SUBJECT: Emergency Diesel Generator Fuel Oil
Quality Technical Specification Changes

PHILADELPHIA ELECTRIC COMPANY
PEACH BOTTOM ATOMIC POWER STATION
UNITS 2 AND 3
DOCKET NOS. 50-277 AND 50-278

ATTACHMENT 1
PIPING AND INSTRUMENT DRAWING M-323 REVISION 13

P 3 I D
FUEL AND DIESEL OIL SYSTEM

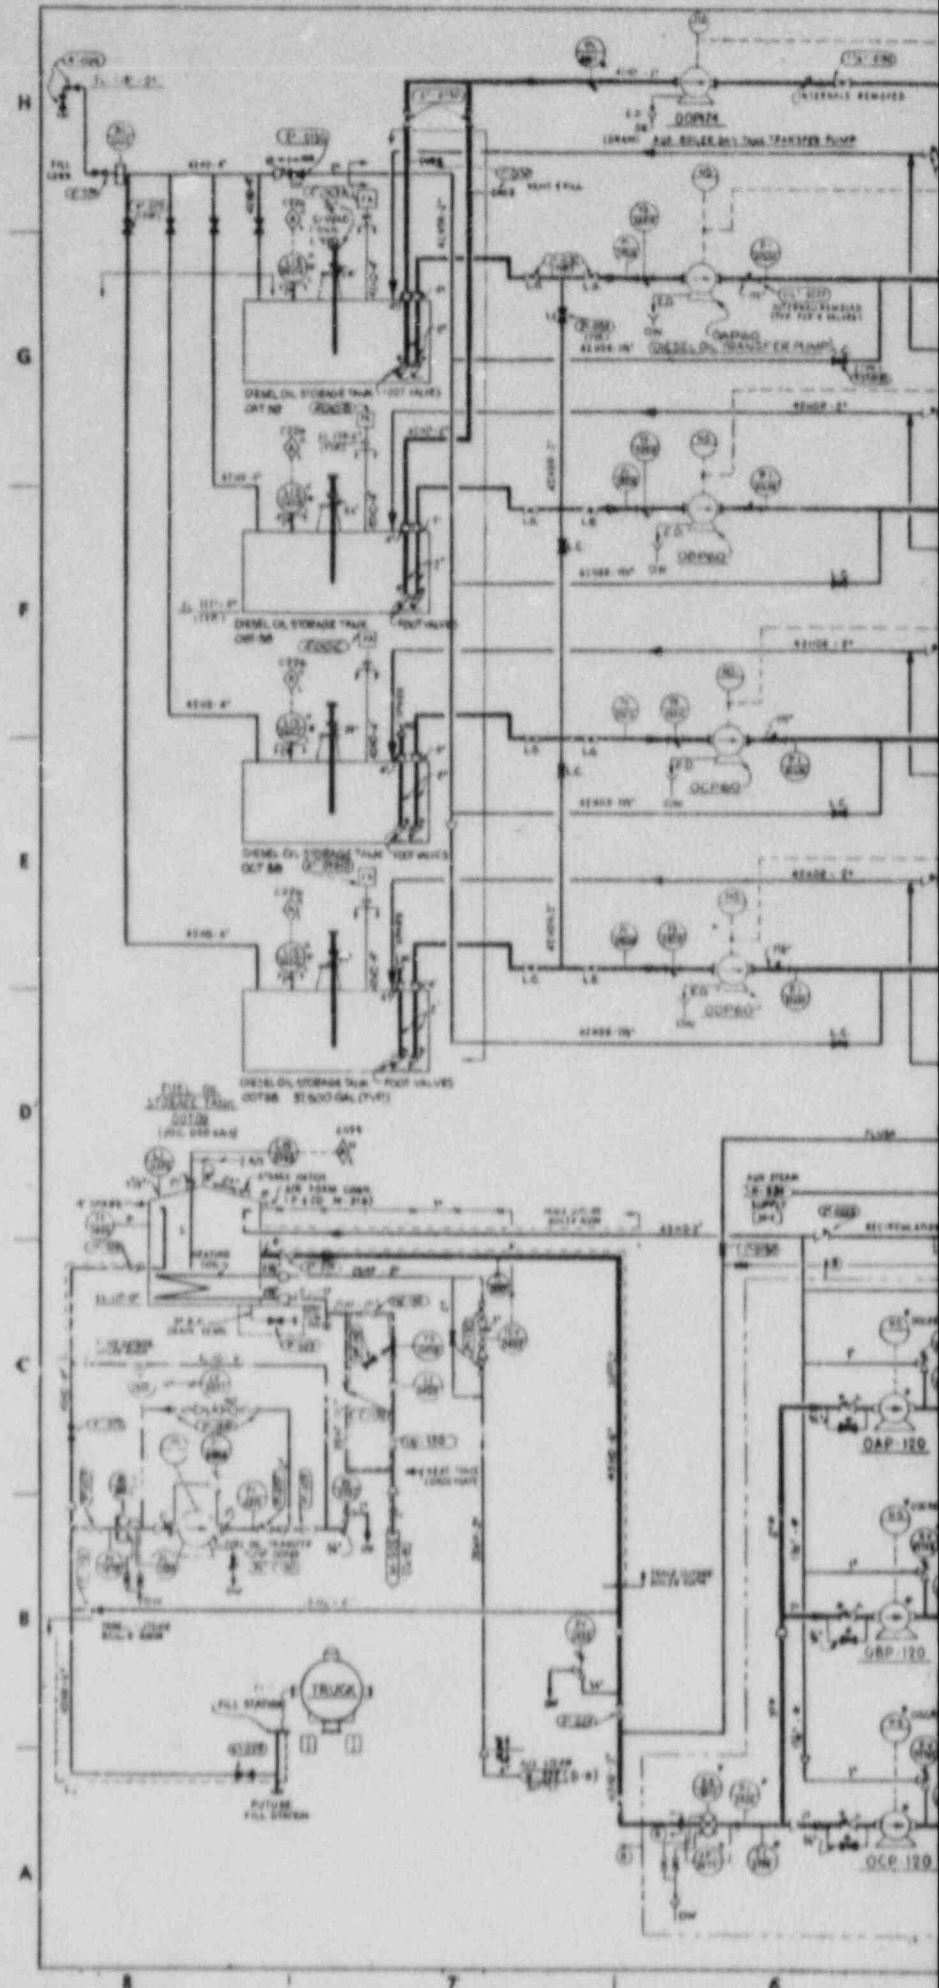
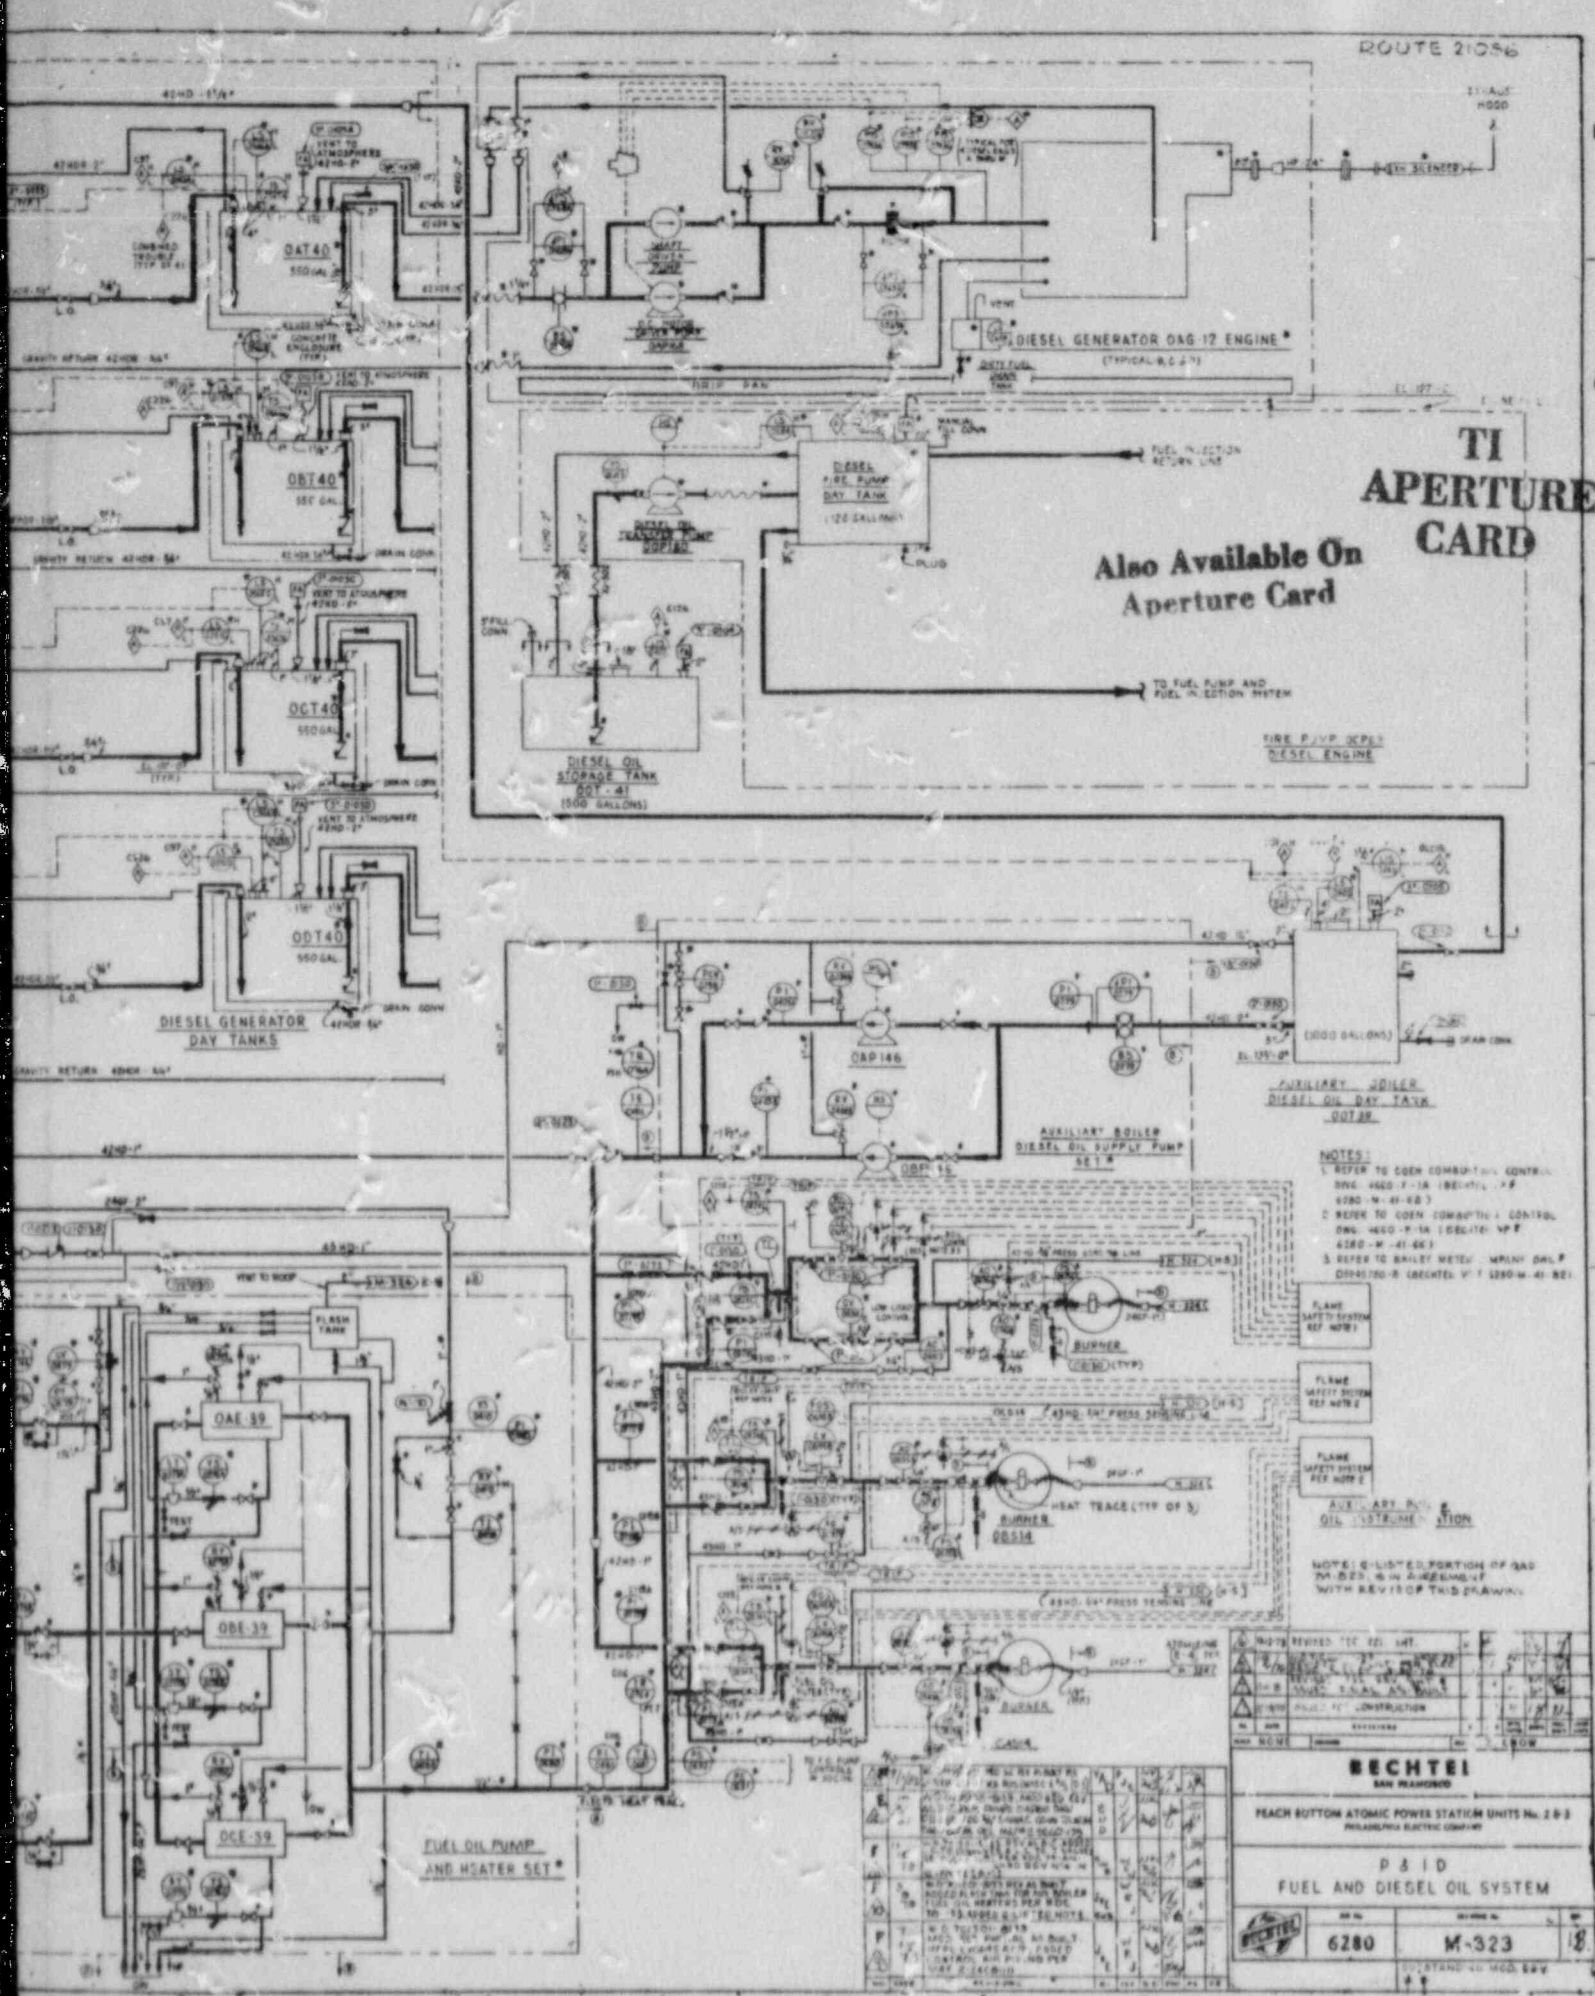
- 2a. Provide an up-to-date fuel oil storage system piping diagram and describe how you comply with GDC-17 independence requirement for on-site ac power systems when operating four diesels from three storage tanks containing a minimum of 104,000 gallons of fuel.

Stirring of sediment during the addition of new fuel oil will not lead to the degradation or failure of the associated diesel generators. As shown on P&ID M-323, a basket strainer is provided on the fill connection to prevent solid particles or debris from entering the fuel oil storage tanks. In addition, a strainer is provided on each diesel oil transfer pump suction line to prevent solid particles or debris from entering the day tank. This is followed by a basket strainer on the suction of the engine-driven and D.C. motor-driven fuel oil pumps, and a duplex filter on the fuel oil pump discharge header. These latter two devices are equipped with differential pressure switches which will actuate alarms at the local control panel and the common diesel generator trouble alarm in the control room before the elements become clogged to the point where fuel oil flow is degraded.

In addition, the fuel oil transfer pump suction is taken approximately four inches from the bottom near one end of the tank. The fill nozzle is located at the opposite end of the tank and discharges through the top of the tank. This is nearly 43 feet horizontally and 12 feet vertically away from the suction line. Sediment will not be stirred when the tank is replenished because agitation of the fuel oil

An up-to-date copy of the diesel generator fuel oil storage and transfer system P&ID (P&ID M-323) is provided as Attachment 1 to this response. As shown on this drawing, each of the four diesel generators is provided with a separate fuel oil storage tank, fuel oil day tank, and fuel oil transfer pump. Each fuel oil day tank can be filled from any of the storage tanks using any of the fuel oil transfer pumps. This provision was included in the design so that in the event of fuel oil contamination, or a fuel oil transfer pump failure, the maximum number of diesel generators will still be available to provide emergency power. In the event that unacceptable fuel oil is found in one main tank, PECO believes that the associated diesel generator can remain operable for the following reasons:
